Town of Mammoth Lakes

Planning & Economic Development Commission Staff Report

AGENDA TITLE: Consideration of Tentative Tract Map 24-002, Use Permit 24-001, and Major Design Review 24-001 for approval of the “Rockspring” resort condominium development project located in the “Resort General” zone of the North Village Specific Plan (NVSP) at the northeast corner of Main Street and Minaret Road. A CEQA conformance analysis was prepared pursuant to the California Environmental Quality Act (CEQA) Guidelines, which finds the project to be in conformance with the certified 1999 North Village Specific Plan Subsequent Program Environmental Impact Report (SPEIR).

PROJECT SITE PLAN

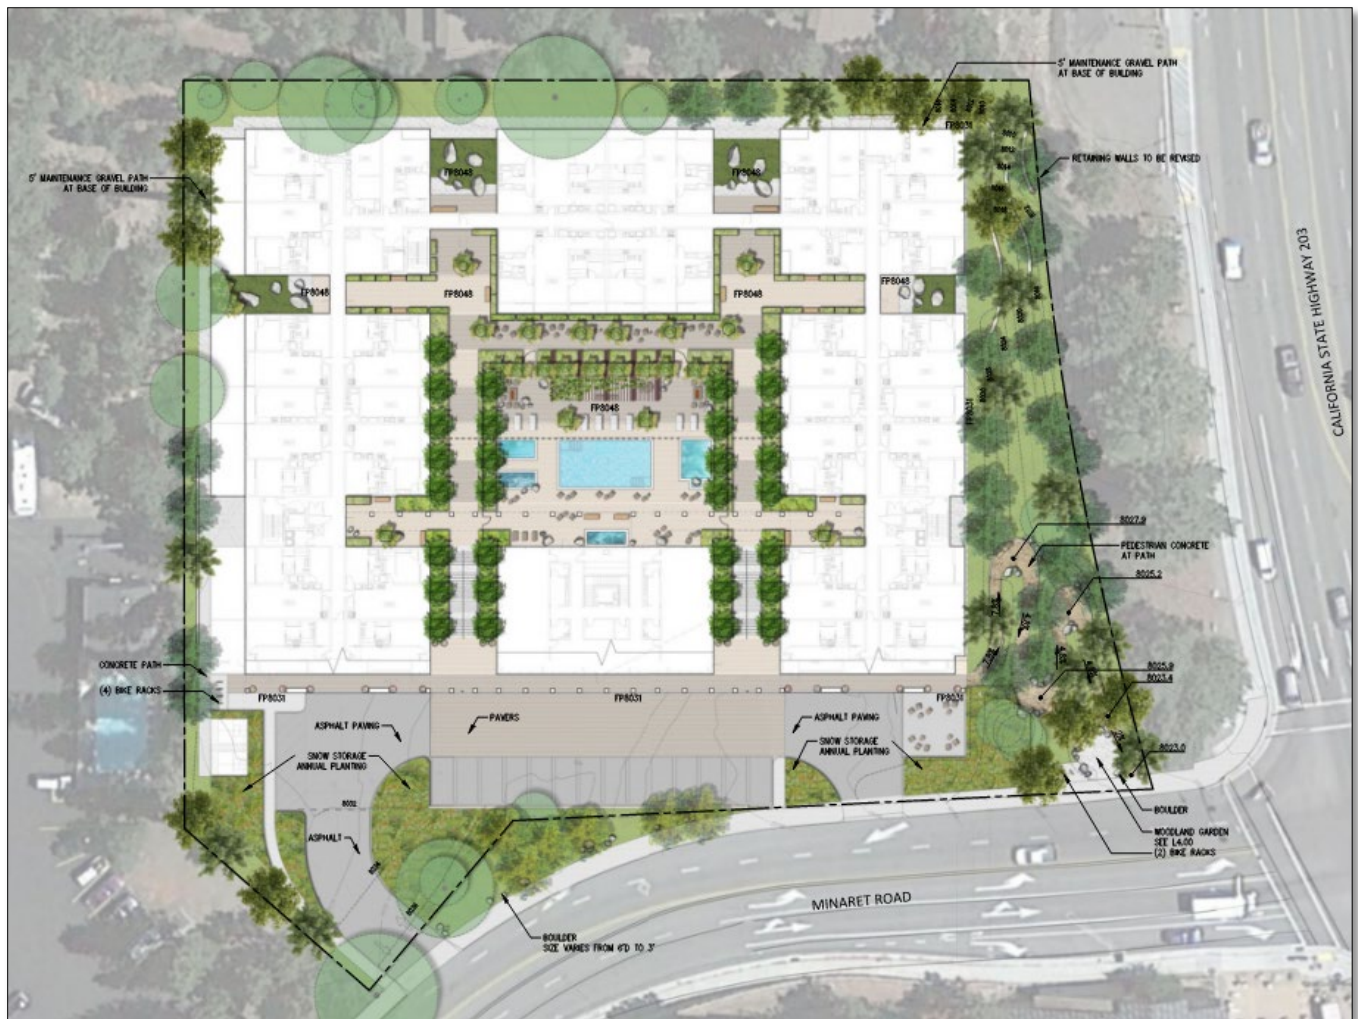
ADP Consensus Comments – 10/26/23	
Site Design:	• Give pedestrians the ability to stroll through the courtyard and through the trees. A meandering pathway to the pedestrian plaza and the arcade feature is recommended to allow pedestrians to take a detour through the property. The Minaret Road sidewalk is busy and is not a comfortable/desirable walking path for pedestrians. • Create a pedestrian park space at the southwest corner of the site to attract visitors and include bike racks. • Amenities developed at the southwest corner of the property should animate that corner and add visual interest while providing a buffer between the street and the project. • The southwest corner should be designed to welcome guests to the Village. • The site design should take advantage of the existing vegetation around the site and preserve as many trees as possible, especially near the southwest corner of the site.

Parking/vehicle circulation:	• The exterior parking spaces at the southern portion of the parking aisle should be screened more effectively with landscape. • Bicycle racks are needed within the project site for short-term bike parking.
Building Design:	• The Building Massing would be improved by stepping down the structure height at the edges of the project. • Realistic renderings from all sides of the project should be provided.
Roof Form:	• The tower roof elements slope back into the primary roof line which will collect snow that is held on the roof structure, which can cause damage. These elements should be a dormer style or other design so that it does not slope back into the roof. • Provide mitigation measures for shedding roof such as heated eave overhang with a steel gutter. This will save a lot in maintenance and labor.
Materials:	• The cast in place concrete walls may be appropriate if the material samples are reviewed by ADP. The applicant team must provide samples of the form liner finish and integral color finish. The applicant team will need to provide a large sample and examples from other projects that have used this form liner. • The horizontal windows on the tower elements should be enlarged to maximize views. • ADP recommends using the dark earthy red option, not the brighter red color on the material board.

Other Design Considerations:	• The snow storage plan needs to address temporary snow storage areas and snow hauling. • The landscape plan should be revised to preserve as many existing trees as possible.

ADP Consensus Comments – 2/1/24	
Site Design:	• ADP appreciated the addition of the concrete stairway providing additional pedestrian access. (This element was removed from the final design). • ADP recommends extending a pedestrian walkway around the south side of the building.
Building Design:	• The fractured stone design for the concrete form liner provided on the physical material board is preferred over the linear design depicted on the revised building materials sheet. • The flat roof on the tower features should incorporate a larger coping on the roof edge. • The gable roof design at the Minaret Road frontage should be maintained and should incorporate layered fascia for improved detailing.

Design Revisions made in response to ADP Consensus Comments	
Site Design:	
• A meandering pedestrian walkway with bench seating has been added. (ADP comment response). • A pocket park / garden seating area with bike racks has been added to the southwest corner of the property and is connected to the meandering pedestrian path. (ADP comment response). • Landscape areas were adjusted to preserve additional existing trees. (ADP comment response). • Additional landscape is provided to screen the south end of the exterior parking aisle. (ADP comment response). • A concrete pedestrian stairway was added at the southeast corner of the property to provide access from the public sidewalk.	
Building Design:

• The architectural style was changed from alpine chalet to a contemporary architectural style. • The primary roof form is changed to a pyramid hip roof form. The north and south sides of the project located on the Minaret Road frontage still feature a gable roof design on the west facing façade. • Roof forms on the tower features were revised to a flat roof to prevent excess accumulation of snow on the primary roof structure. (ADP comment response).

- Windows on the tower features have been enlarged and are vertically oriented. (ADP comment response).
- The color palette changed to remove the earthy red accent color.
- The form liner pattern for the concrete walls changed to a contemporary linear pattern.
